**ADDENDUM NO. 01 – PORTAGE PUBLIC SCHOOLS – HAVERHILL ELEMENTARY SCHOOL BP 6:
CONSTRUCTION**

ADDENDUM NO. 1 (BP 6)

DATE OF ISSUANCE:	July 26, 2023
PROJECT:	Haverhill Elementary School Bid Package 6: Construction 6633 Haverhill Avenue Portage, MI 49024
OWNER:	Portage Public Schools
ARCHITECT'S PROJECT NO.:	21-237.20
ORIGINAL BID ISSUE DATE:	June 30, 2023

SEE "AT CIRCULATION RISERS" FOR INFORMATION NOT SHOWN

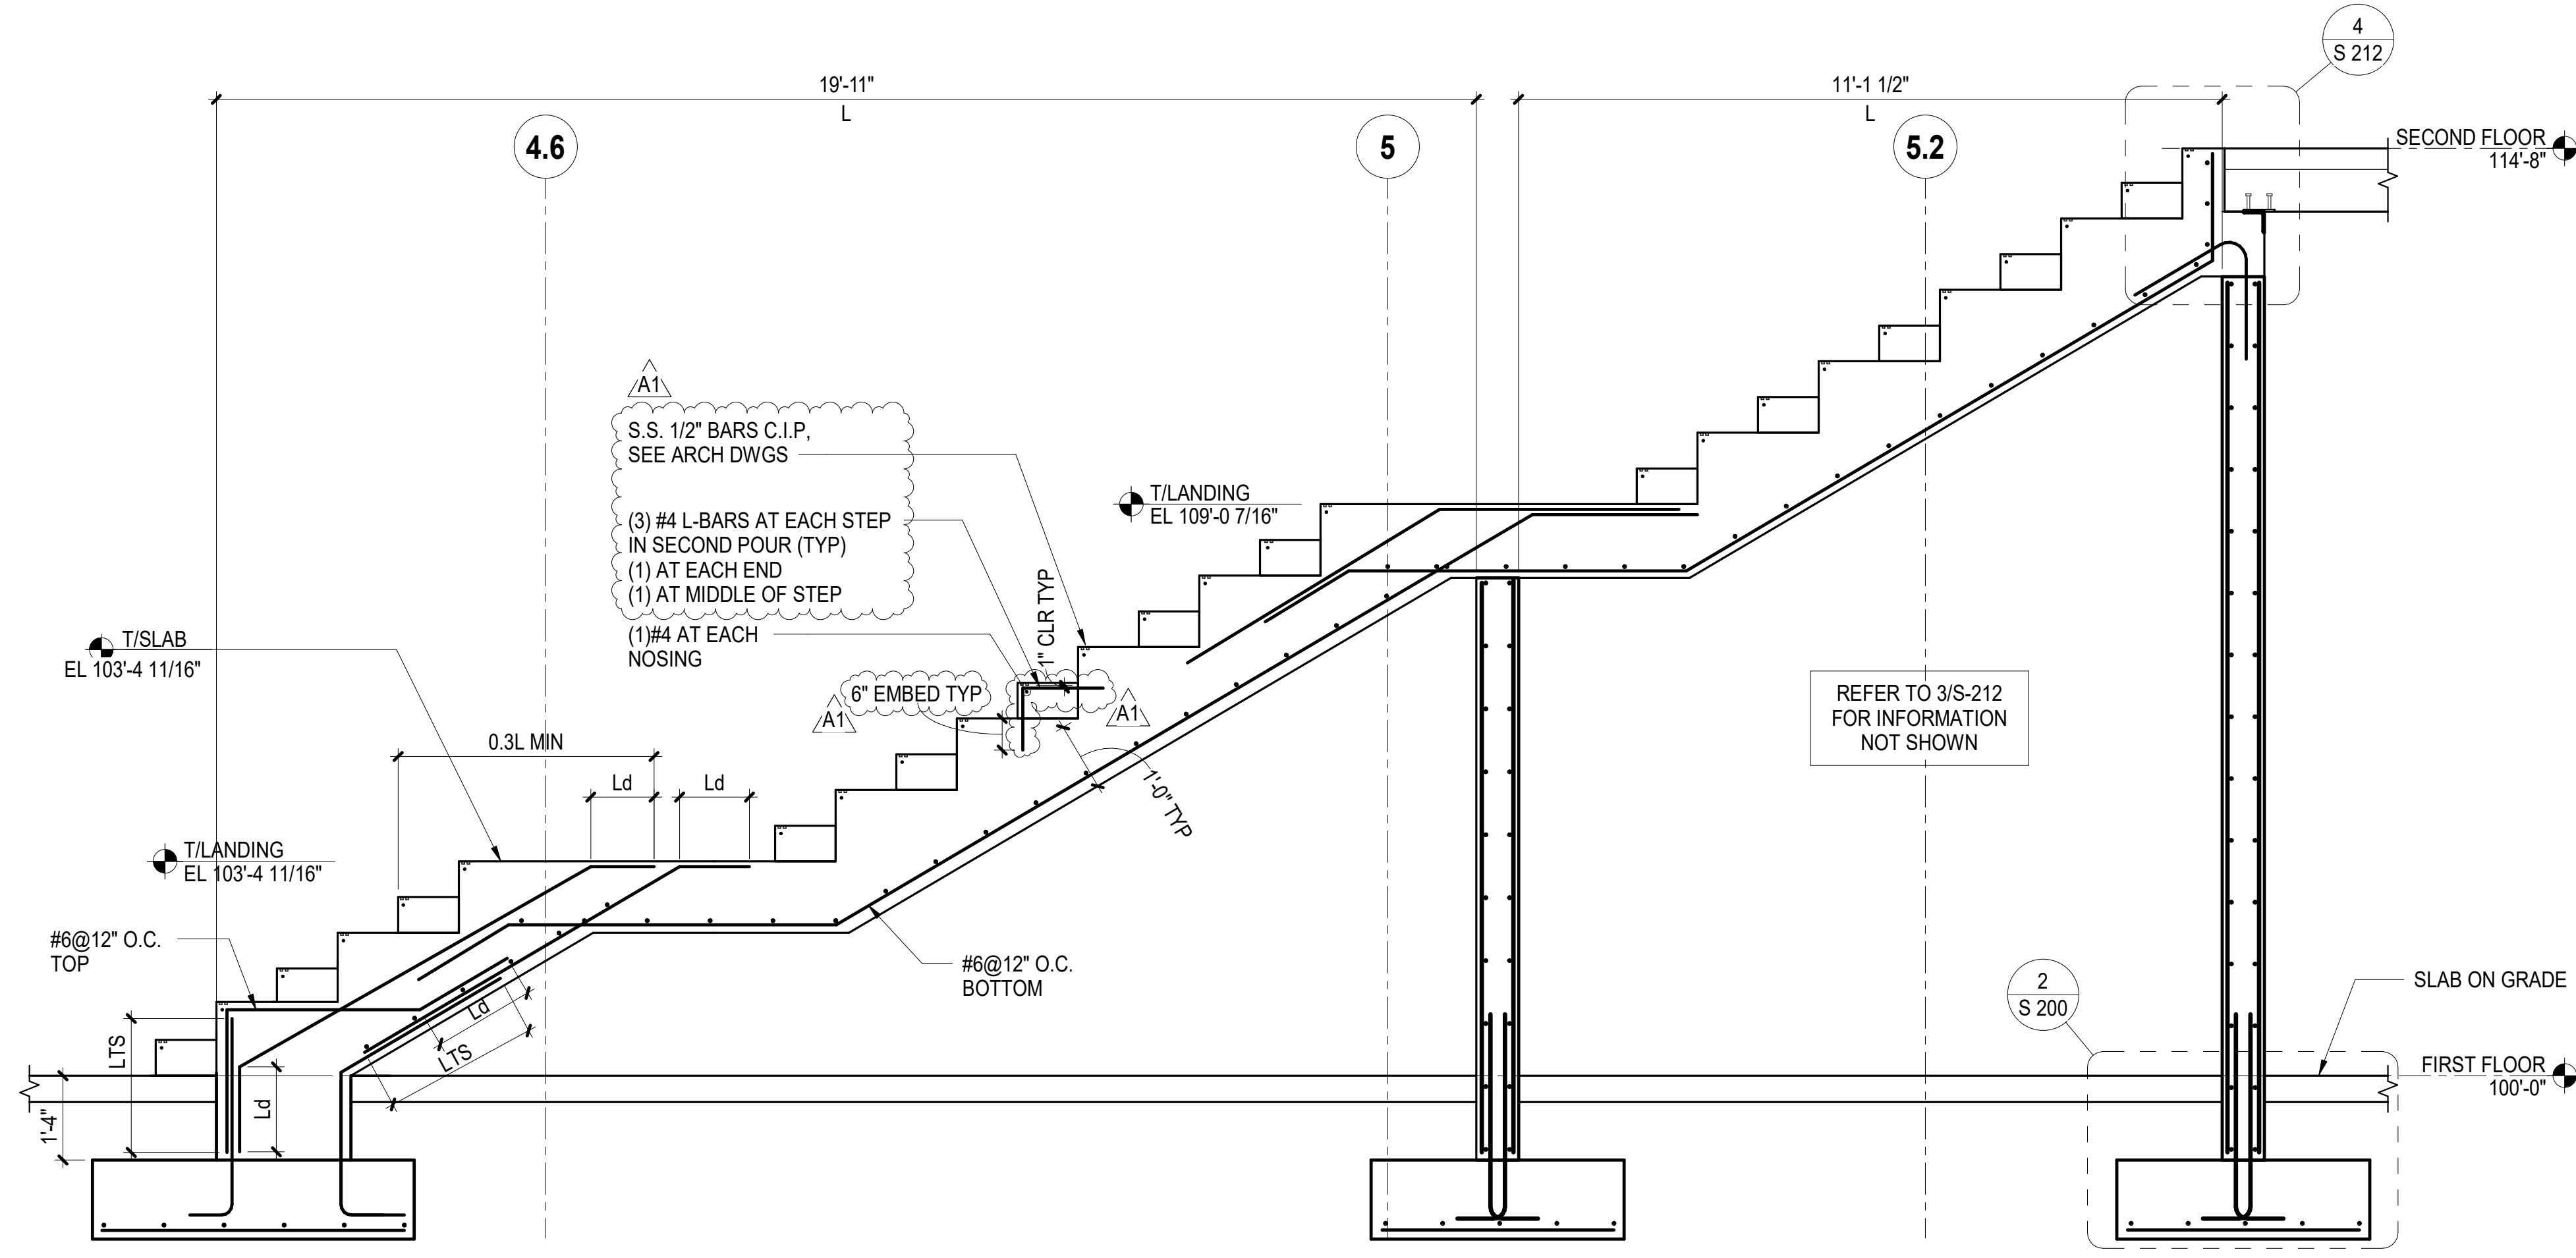
Added stair nosings per architectural drawings

8 FLANGE PLATES AT EXTERIOR LINTELS SUPPORTED BY STEEL POSTS
3/4" = 1'-0"

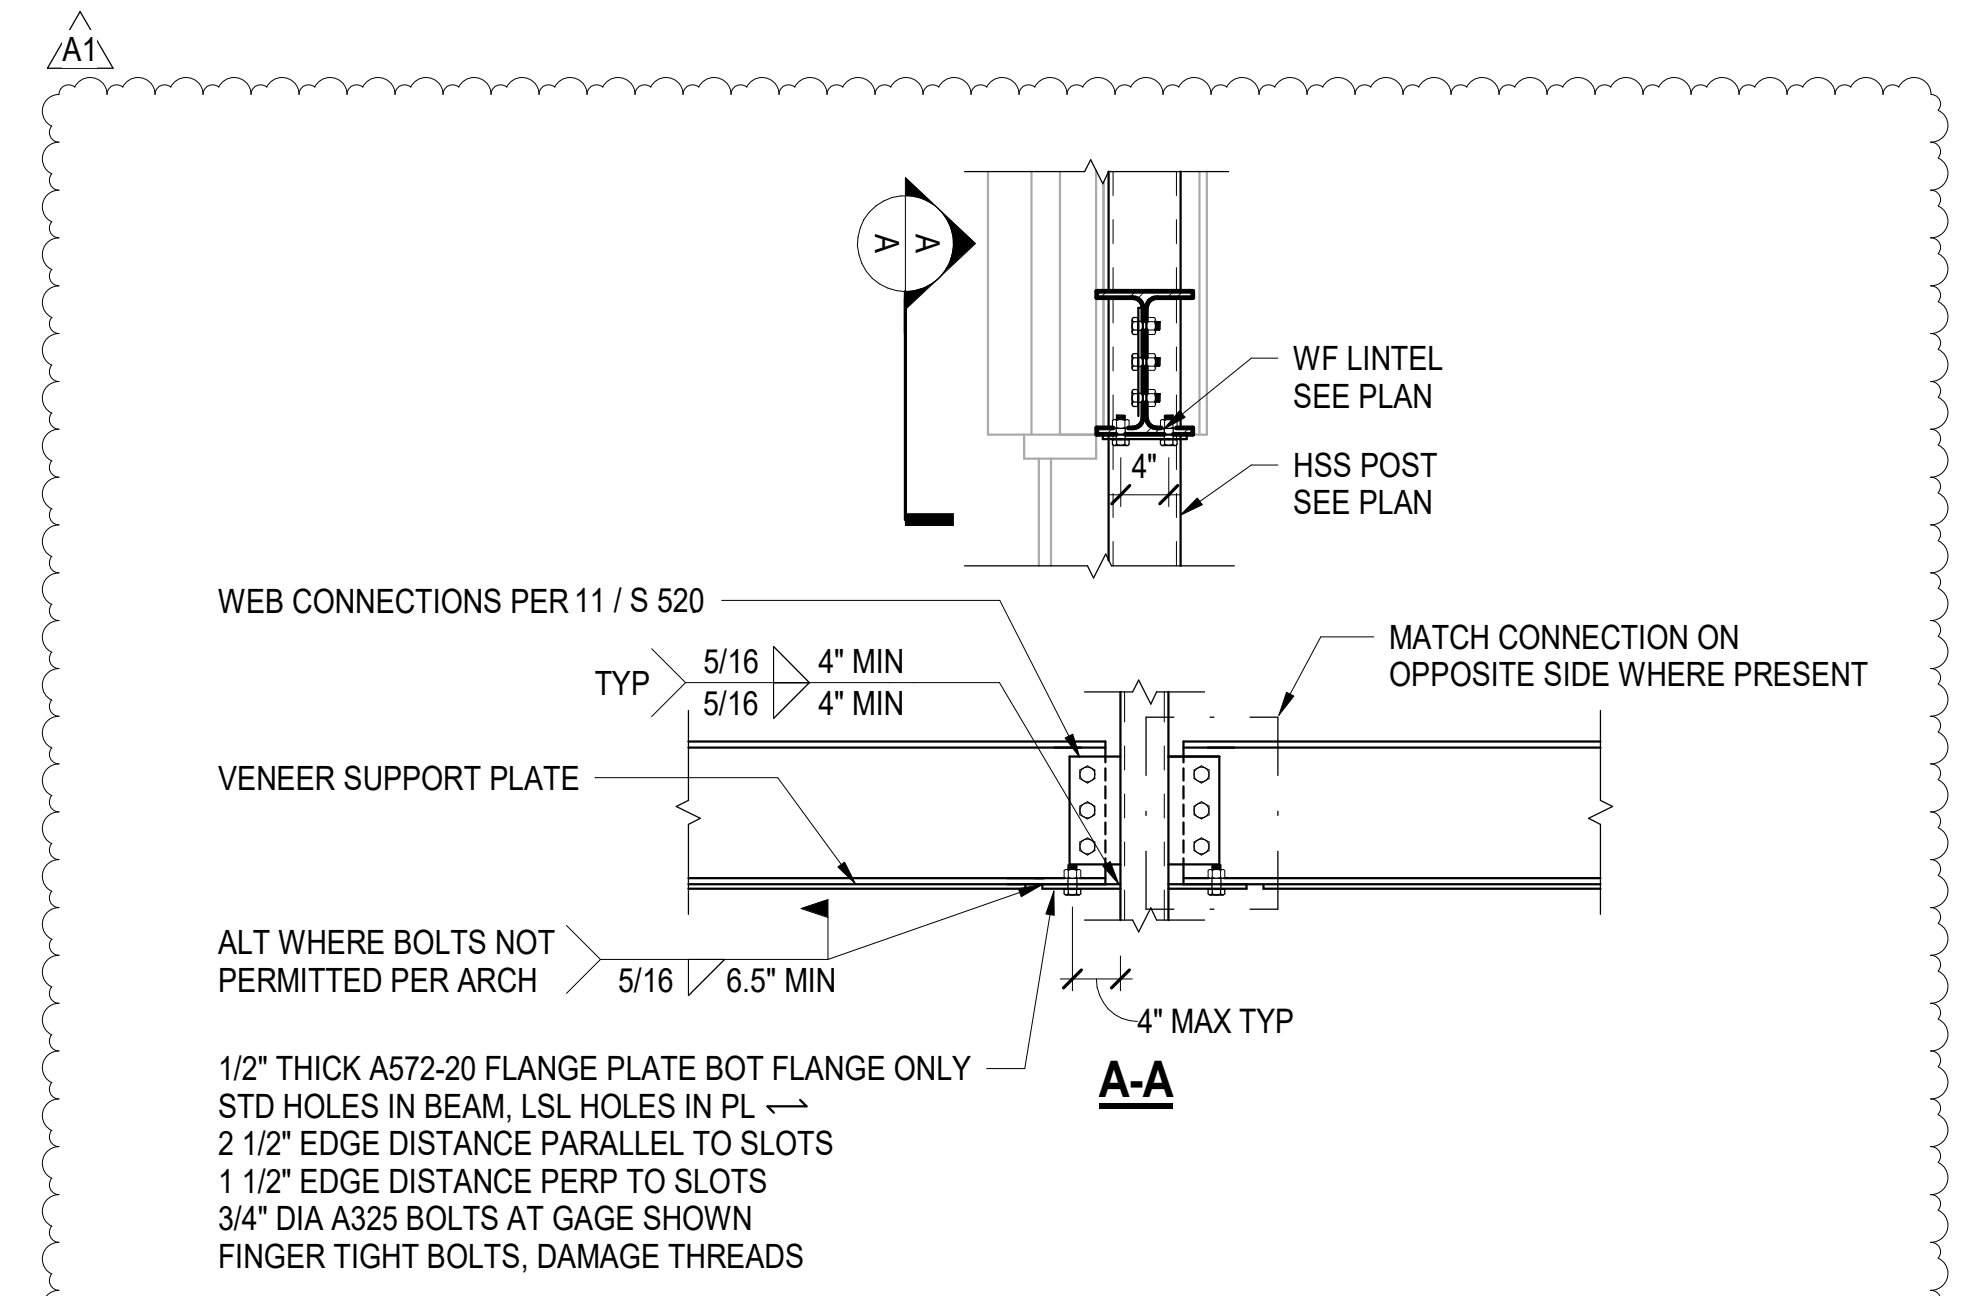
Provided detail for flange plates at exterior lintels supported by HSS posts

2A DRAG STRUT TO CMU WALL AT CORNER SKEWED CONDITION, 12\"/>

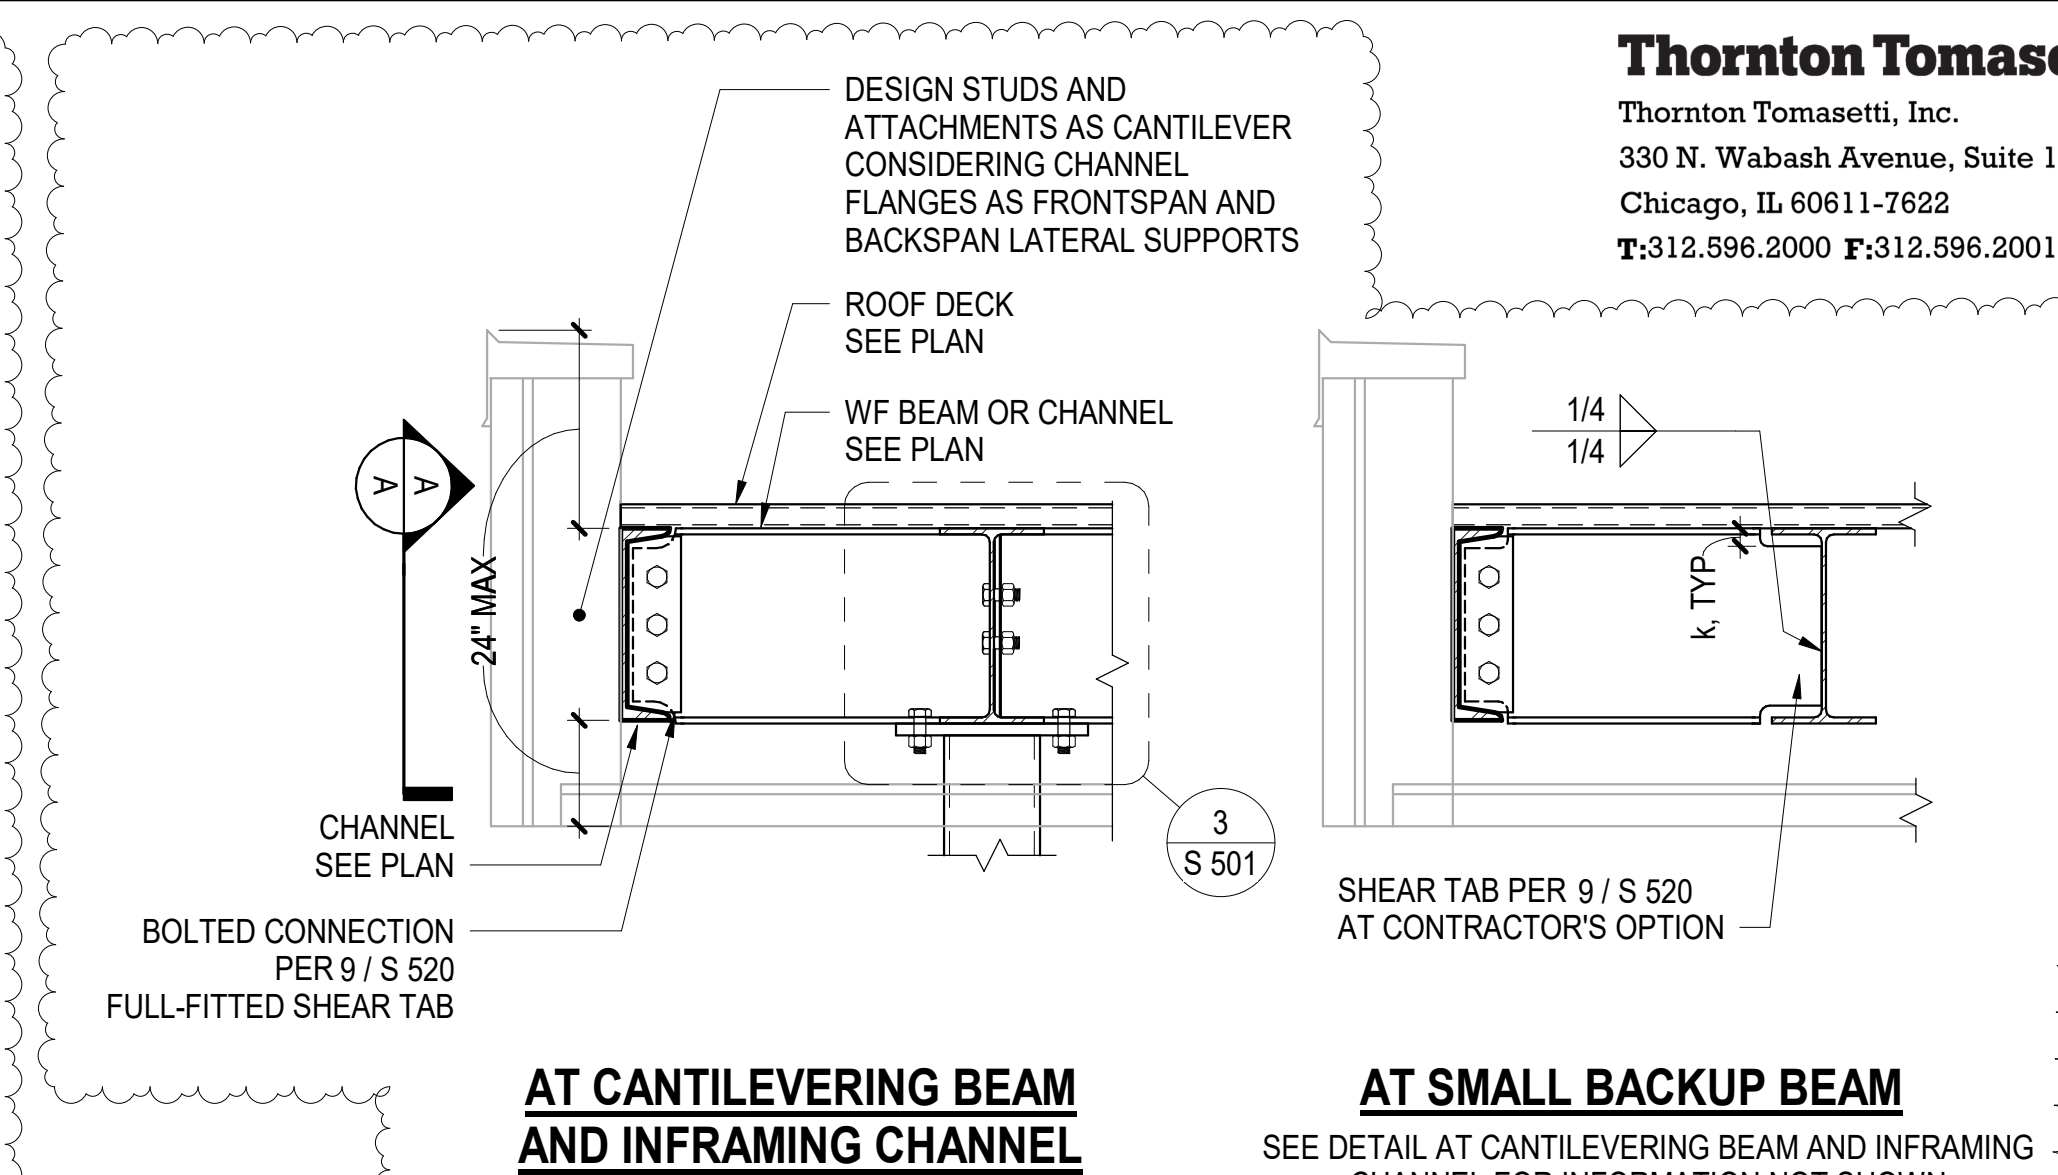
Provided detail to clarify requirements at skewed drag strut condition

3 BUILDING SECTION
1/8" = 1'-0"

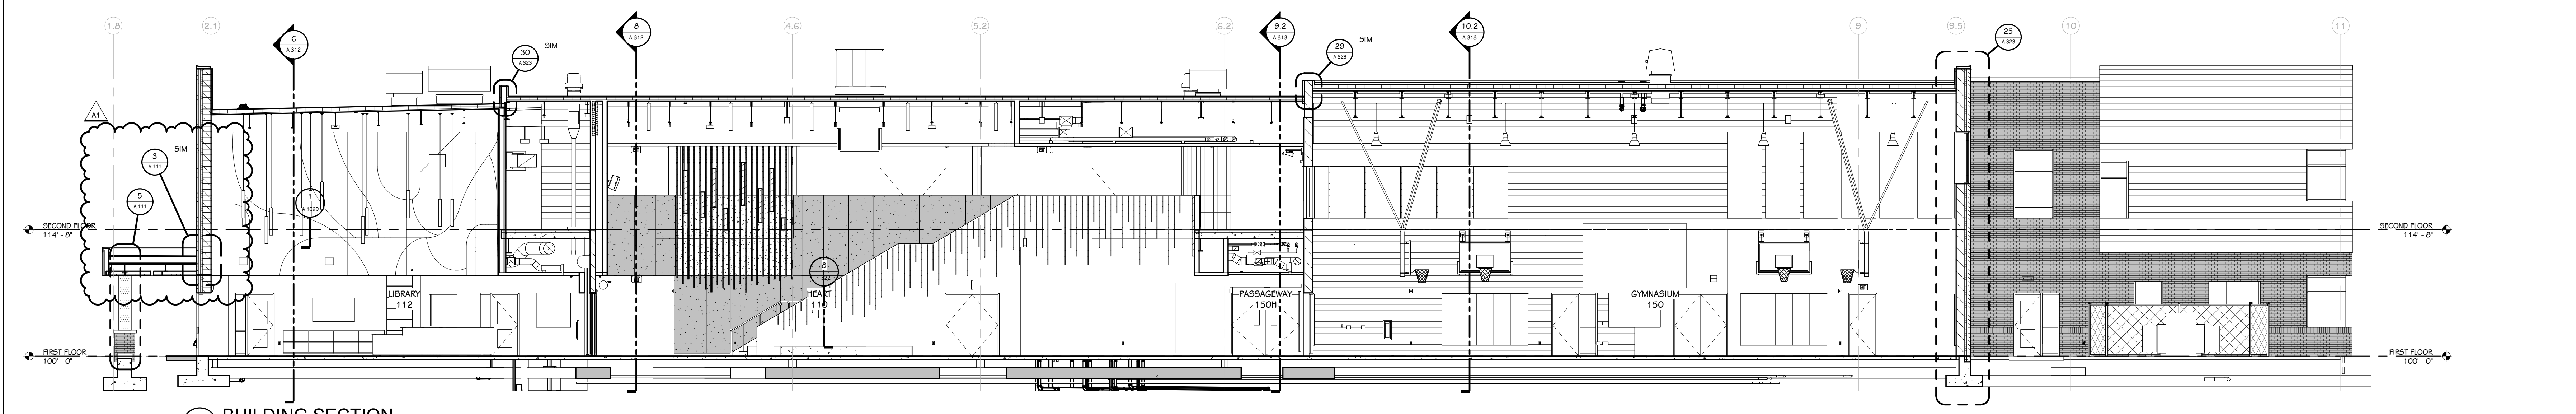
Updated canopy details 2/A111 and 3/A111. Added callout to building section 3/A311.
